Crystal River Nuclear Plant  
Docket No. 50-302  
Operating License No. DPR-72

Subject: Crystal River Unit 3 – Response to Request for Additional Information for the Review of the Crystal River Unit 3 Nuclear Generating Plant, License Renewal Application (TAC NO. ME0278) – Environmental Review

Re: Progress Energy Florida, Inc. –Crystal River Units 1, 2, & 3  
DEP File No. FL0000159-013-IW1S/NR  
Request for Additional Information (RFI) No. 1  
NPDES Permit Renewal Application

FIGURE 2

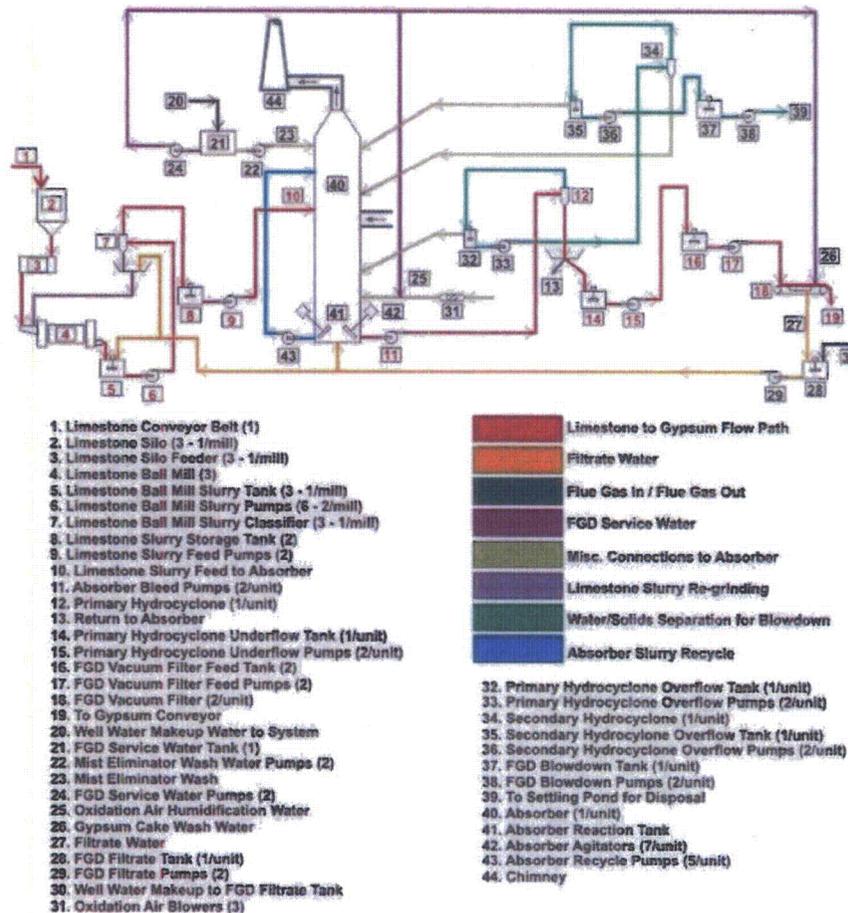
- 8. Please provide a detailed description of the FGD operations, including wastewaters generated by production and storage of any gypsum, the final disposition of these wastewaters, whether the FGD system is connected to selective catalytic or noncatalytic reduction units, and the FGD blowdown treatment system.**

Figure 2 illustrates the mass balance diagram for the entire FGD process. The RED line illustrates the flow path from limestone to gypsum, starting with #1 and ending with #19.

The FGD process starts with receiving limestone that is ground into a slurry product (calcium carbonate). This is called the Limestone Preparation System. The limestone is used to quench the boiler exit flue gas while at the same time removing sulfur dioxide (SO<sub>2</sub>) from the flue gas. This SO<sub>2</sub> removal occurs in the absorber module. Removing SO<sub>2</sub> is the primary function of the absorber module. The cleaned flue gas is then discharged to the atmosphere through the associated gas stack flue. The SO<sub>2</sub> that is removed from the flue gas mixes with the limestone slurry. The limestone slurry returns to the bottom of the absorber known as the Absorber Reaction Tank. Forced oxidation air is injected into the absorber reaction tank where “calcium sulfate”, also known as “synthetic gypsum.” is generated. Synthetic gypsum is commonly used to manufacture wallboard. The Gypsum Preparation System rinses and dewateres the synthetic gypsum for sale to a wallboard manufacturing company.
